**schema 3: revisions to scheme 2**

- REV F 09 Mar 2022 G/M/G  
 The previously approved scheme (scheme 2) is altered to include a number of minor, non-material amendments: the amendments included mostly rationalise the alterations at Rev E
- REV E 06 Sep 2021 G/M/G  
 The previously approved scheme (scheme 2) is altered to include a number of small amendments.
- REV D 15 Jan 2021 G/M/G  
 Planning Application further revised, in response to planning and conservation officers comments.
- REV B 10 Aug 2020 G/M/G  
 Revised Planning Application marked at Revision B
- REV A 05 Dec 2019 G/M/G  
 Original Planning Application marked at Revision A

**PROJECT**  
**The Hoo: Scheme 3**  
**17 Lyndhurst Gardens,**  
**Hampstead, London**  
 Returning a Grand Victorian House to Private Domestic Accommodation NW3 SNU

**DRAWING**  
**Lower Ground Floor Layout**  
**as Proposed**

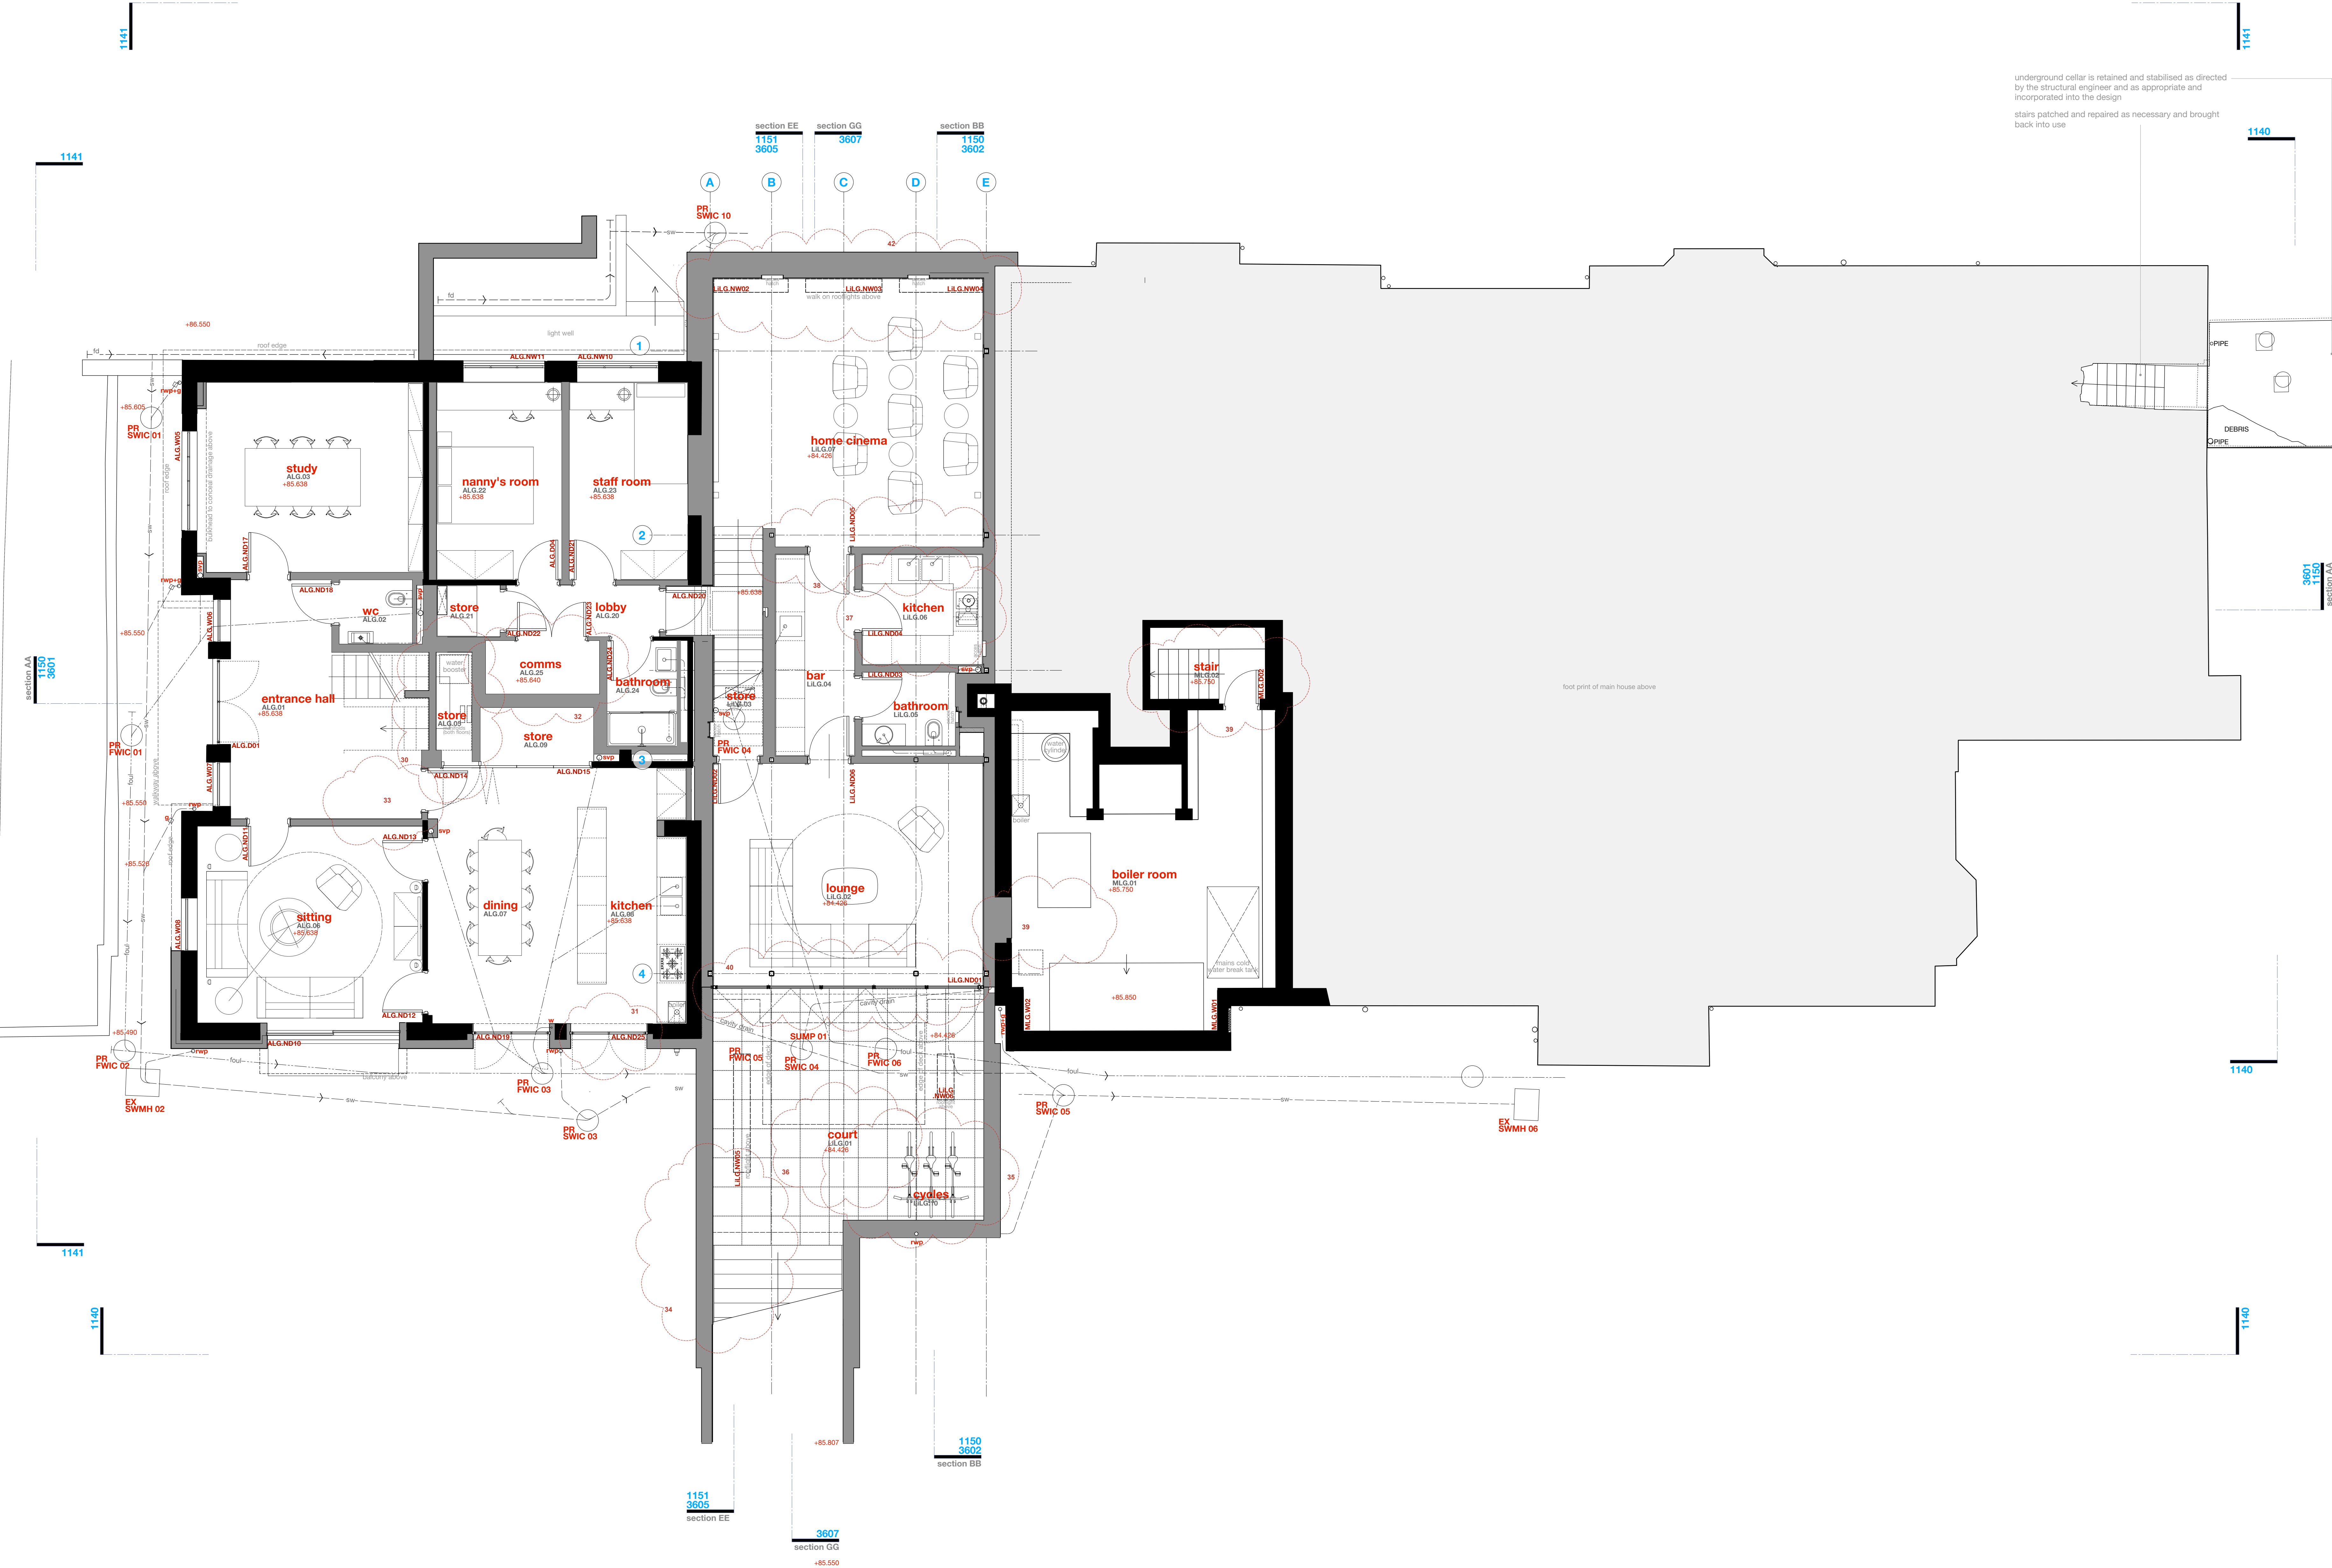
- 30 1907's annex: additional demolition shown
- 31 1907's annex: additional bench door included
- 32 1907's annex: kitchenette becomes comms room, store wall moves northwards
- 33 1907's annex: kitchenette removed
- 34 kitchen garden stone is omitted and width of step is increased westwards to compensate
- 35 position of cycle parking is amended
- 36 courtyard is added in, walk-on rooflights provide natural light, comms room becomes kitchen
- 37 internal wall moves northwards to increase the area of ancillary accommodation
- 38 access to plant room from lower ground floor level is omitted, original access repositioned to comply with the strategy
- 39 static wall becomes sliding folding door with leading pass door
- 41 walk on roof lights are removed

**Ground Floor Layout  
 as Proposed**

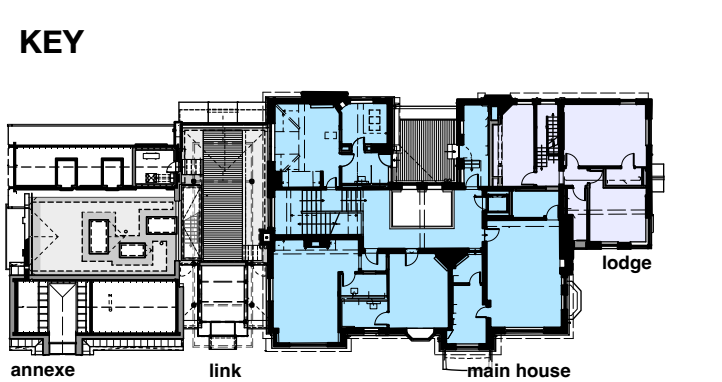
- 30 1900's annex: ceiling modified to incorporate roof lights
- 31 1900's annex: window openings widened further
- 32 fix: fix glass elevation at rear omitted in favour of glass box

- 33 fix: walk on roof lights removed to accommodate adjacent glass box
- 34 fix: open areas of roof terrace are now roofed in, walk on rooflights provide natural light to lower ground floor

- 35 ground area is removed and stairs are widened westwards to compensate
- 36 access to plant room is re-installed and upgraded to current fire regulations

- 37 original pocket door discovered during minor opening up, original doors, ironmongery and mechanism are to be refurbished and reinstated
- 38 existing former opening is widened further

- 39 rwp repositioned to simplify drainage and tidy elevation
- 40 stairs are amended, one step is removed
- 41 steps are amended, one new step is included to allow minimal head height in courtyard LA.001, lower ground floor

- 42 additional existing walls are removed from the annex and replaced with new partitions, as a consequence of removing the pot and beam structure at ground floor level, this is replaced with metal web joists that allow a sprinkler fire fighting system to be installed, as required by the London fire brigade.

DRAWING  
**First Floor Layout**  
**as Proposed**

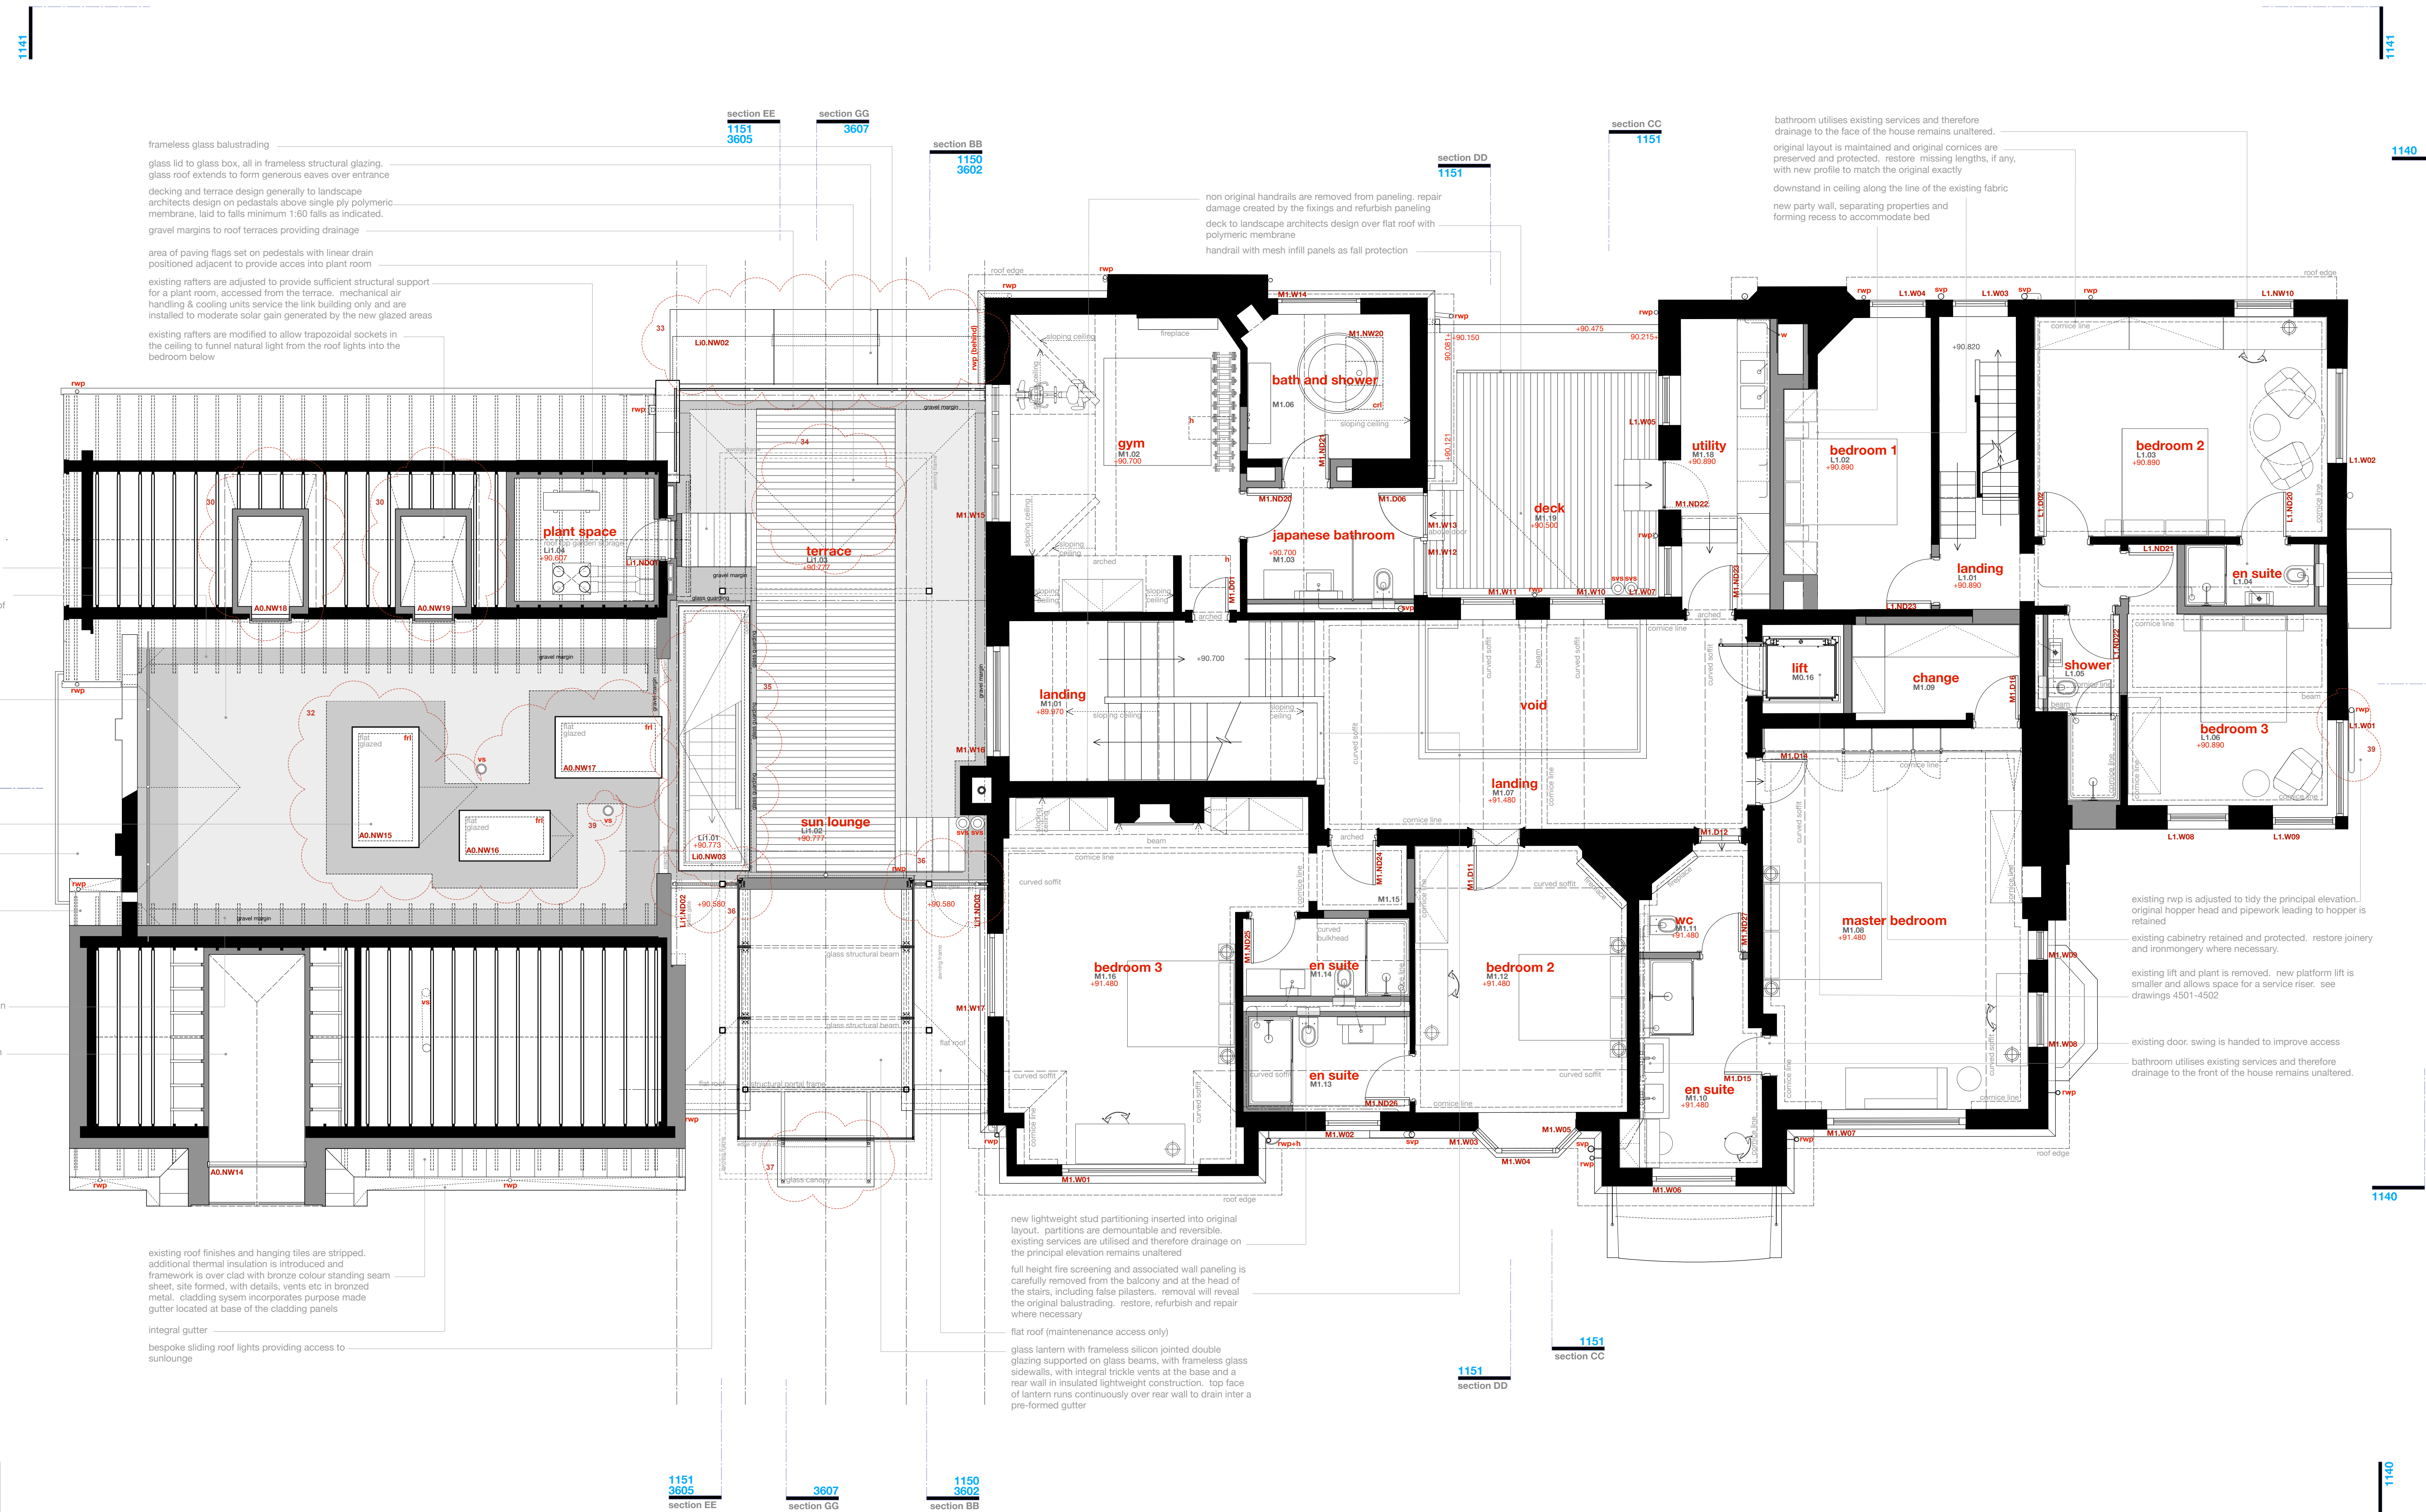
- schema 2: revisions to scheme 2**
- 30 1980's arnese ceiling modified to incorporate roof lights
  - 32 1980's arnese rooflights in flat roof are replicated

- 33 link: flat glazed rear elevation omitted in favour of projecting glass box with glass lid
  - 34 walk-on roof light is omitted
  - 35 box roof light is omitted and replaced by a low profile opening glass hatch giving access onto the roof terrace, including glass glazing as fall protection under the hatch when open. hatch also allows maintenance access to the roof above the arnese

- 36 solid sections of low wall are omitted for glass barriers allowing maintenance access to flat roof and garden through lockable glass gates with 75mm paired steel frames

- 37 new glass canopy protecting staircase from weather
  - 38 ceiling met, east elevation, is re-located to simplify drainage, also all new service penetrations, flues etc are all marked
